### PIT5493C Diagnostic Aid, Fuel Gauge Will Not Read Above OR Below a 1/2 Tank

#### Models

Brand:	Model:	Model Years:	VIN:		Engine:	Transmissions:
			from	to		
Chevrolet	Colorado	2015 - 2020	All	All	All	All
GMC	Canyon	2015 - 2020	All	All	All	All

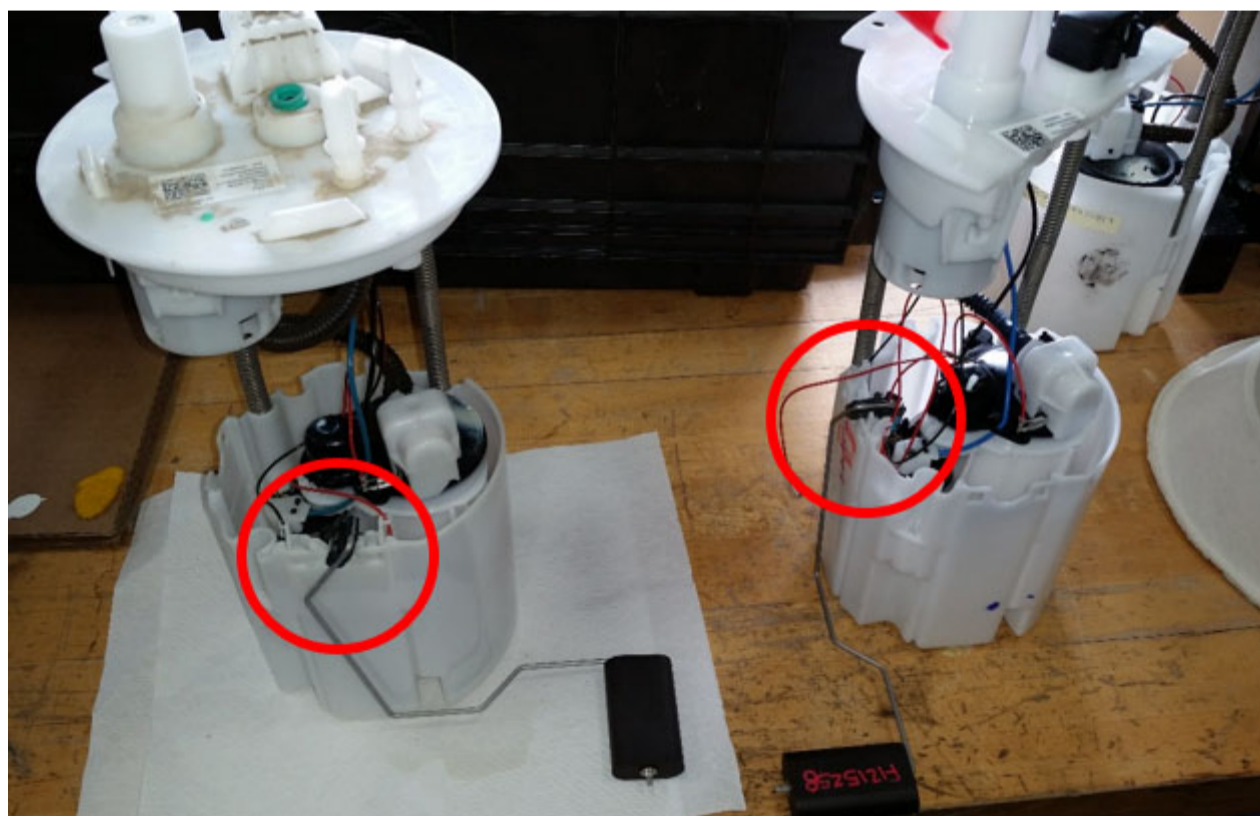
**The technician may report after in tank service the fuel gauge will not go over 1/2 tank or will not go below 1/2 tank.**

**Inspect the fuel level sender and verify it is in the correct slot of the fuel module. In the picture below, the left fuel module reflects the correct location whereas the right fuel module reflects the incorrect position. Install sender in correct slot to repair.**

**The picture below is a cut away of the right fuel module indicating the level sender contacting the side of the fuel tank.**
